# Simplifications and enhancements for P802.1ASdm D1.1 around ptpInstanceState

Author: Johannes Specht

**Date:** 31.07.2023

- 11. Delete 17.5.3.3.
- 12. Replace Figure 17-2 as shown.

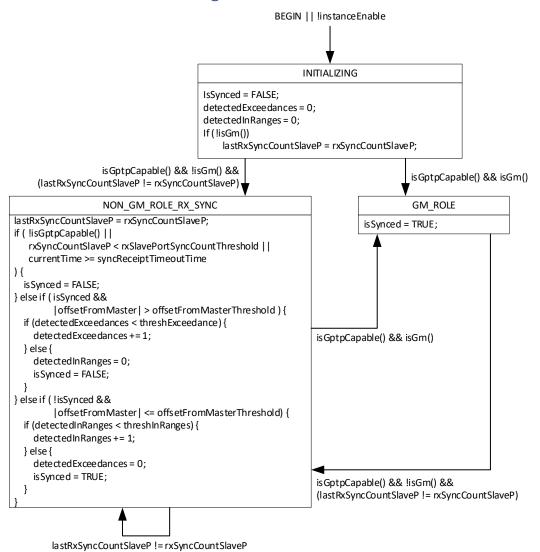
```
if (isGm()) {
 isSynced = TRUE;
} else {
  lastRxSyncCountSlaveP = rxSyncCountSlaveP;
  if ( !isGptpCapable() ||
     rxSyncCountSlaveP < rxSlavePortSyncCountThreshold ||
     currentTime >= syncReceiptTimeoutTime
    isSynced = FALSE;
  } else if (isSynced &&
          |offsetFromMaster| > offsetFromMasterThreshold) {
    if (detectedExceedances < threshExceedance) {
      detectedExceedances += 1;
    } else {
      detectedInRanges = 0;
      isSynced = FALSE;
  } else if (!isSynced &&
          |offsetFromMaster| <= offsetFromMasterThreshold) {
    if (detectedInRanges < threshInRanges) {
      detectedInRanges += 1;
    } else {
      detectedExceedances = 0;
      isSynced = TRUE;
    }
 }
```

- offsetFromMaster is a signed integer. Therefore, |offsetFromMaster| is used instead of offsetFromMaster.
- The code is equivalent with that from D1.1 of P802.1ASdm. However, the intended function may be different than both, that in D1.1 of P802.1ASdm and likewise that in the diagram, because the in-range/out-range counting logic may be intended to scan for consecutive syncs in sequence, rather than over the entire phase while the PTP instance is considered to be "sufficiently" or "insufficiently" synced (e.g., right now, 5 "bad" syncs with threshExceedance=5 would lead to a transition from "sufficiently" to "insufficiently" synched, irrespectively if the 5 "bad" syncs appear in a sequence of 10 or 10000000 syncs).

An alternative for discussion could be a window with the most recent M sync events for which either "good" (|offsetFromMaster| <= offsetFromMasterThreshold) or "bad"

(|offsetFromMaster| > offsetFromMasterThreshold) is stored, and of which at least N entries must be "good" with N  $\leq$  M and with configurable N and M.
